Stage 3: Workgroup Report	At what stage is this document in the process?
<h1 style="color: #008080;">GC0096</h1> <h2 style="color: #008080;">Modification Title: Energy Storage</h2>	<div style="display: flex; flex-direction: column; align-items: center;"> <div style="display: flex; border: 1px solid black; border-radius: 5px; padding: 5px; margin-bottom: 5px;"> <div style="border: 1px solid black; border-radius: 5px; padding: 2px 10px; margin-right: 5px;">01</div> <div style="border: 1px solid black; border-radius: 5px; padding: 2px 10px;">Proposal Form</div> </div> <div style="display: flex; border: 1px solid black; border-radius: 5px; padding: 5px; margin-bottom: 5px;"> <div style="border: 1px solid black; border-radius: 5px; padding: 2px 10px; margin-right: 5px;">02</div> <div style="border: 1px solid black; border-radius: 5px; padding: 2px 10px;">Workgroup Consultation</div> </div> <div style="display: flex; border: 1px solid black; border-radius: 5px; padding: 5px; margin-bottom: 5px; background-color: #008080; color: white;"> <div style="border: 1px solid black; border-radius: 5px; padding: 2px 10px; margin-right: 5px; background-color: #008080; color: white;">03</div> <div st

Figure 2.0

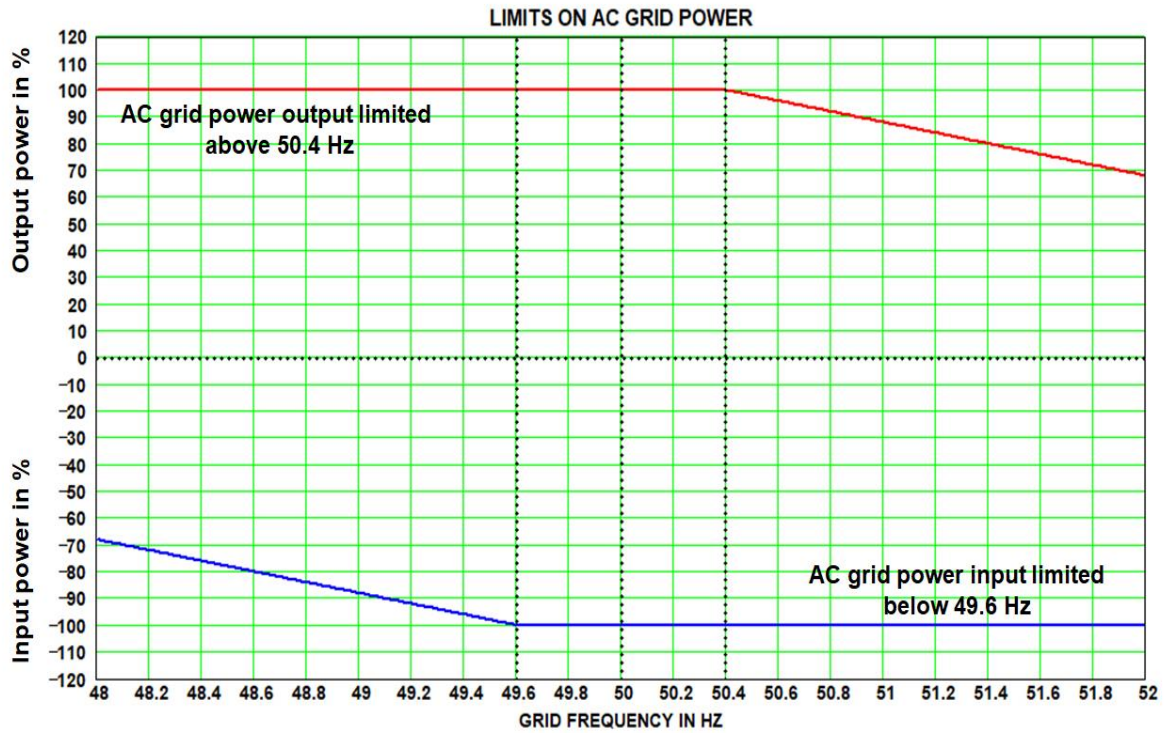
As part of the Workgroup discussions, one Workgroup member noted that storage should have a requirement to cater for limiting power input with falling frequency and limiting power output with rising frequency and proposed the use of the following graph.

The Proposer would however note that the characteristic shown in Figure 2.0 may be more appropriate however as also pointed out by a workgroup member this requirement applies to generation equally as it applies to Storage. As such, and as the aim of the workgroup is to ensure consistent treatment between different classes of User's, this is an issue that should be highlighted as a future area of work as the implications of a change to generation affects a much greater audience.

Figure 3.0 (a)

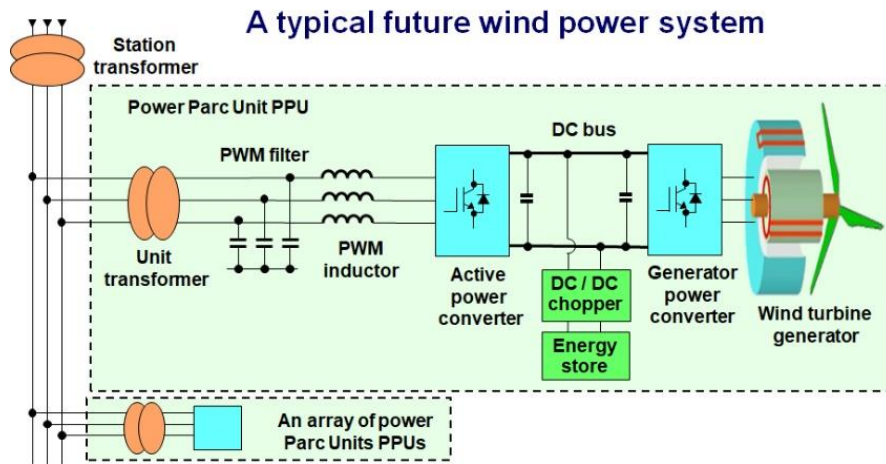
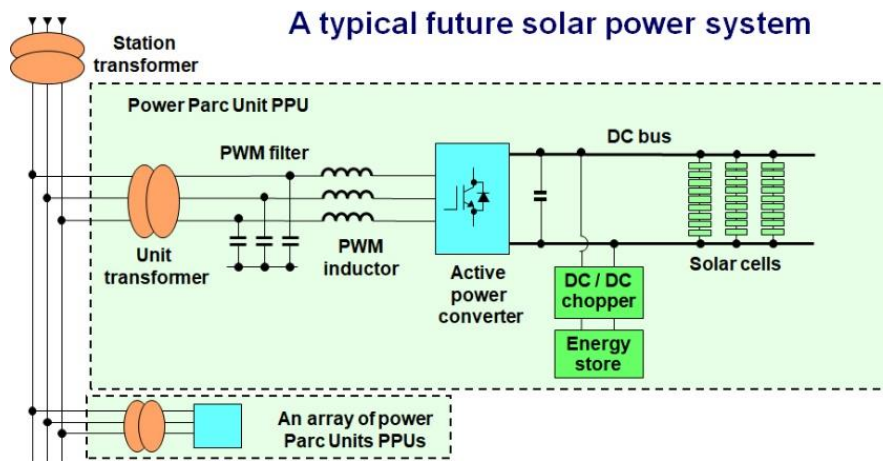
In addition, a Workgroup Member noted that as part of a future co-located site that it was entirely likely that an energy storage technology could be integrated as part of a solar park, wind farm or synchronous plant. Figure 3.0(a) and Figure 3.0(b) below (which have been re-produced in this report with the kind permission of ENTSO-E) illustrate this example for a wind farm or solar park.

One Workgroup member noted that for wind farms and solar parks, the storage elements are not directly connected to the AC system and raised concern that they would not be required to satisfy the requirements of the GC0096 proposals. It was also noted that for rotating synchronous generators this is not so much of an issue.

In response, the Proposer would note that where you have a Power Station comprising of Power Park Modules and/or Electricity Storage Modules, the Grid Code applies to the Power Park Modules and Electricity Storage Modules within that Power Station.

In addition, the Proposer would note that as part of the GC0096 proposals, that when a storage element is operating in a condition analogous to demand, then there is a requirement for this demand to be reduced as frequency falls as defined under OC6.6, in just the same way as pump tripping as part of a pumped storage plant.
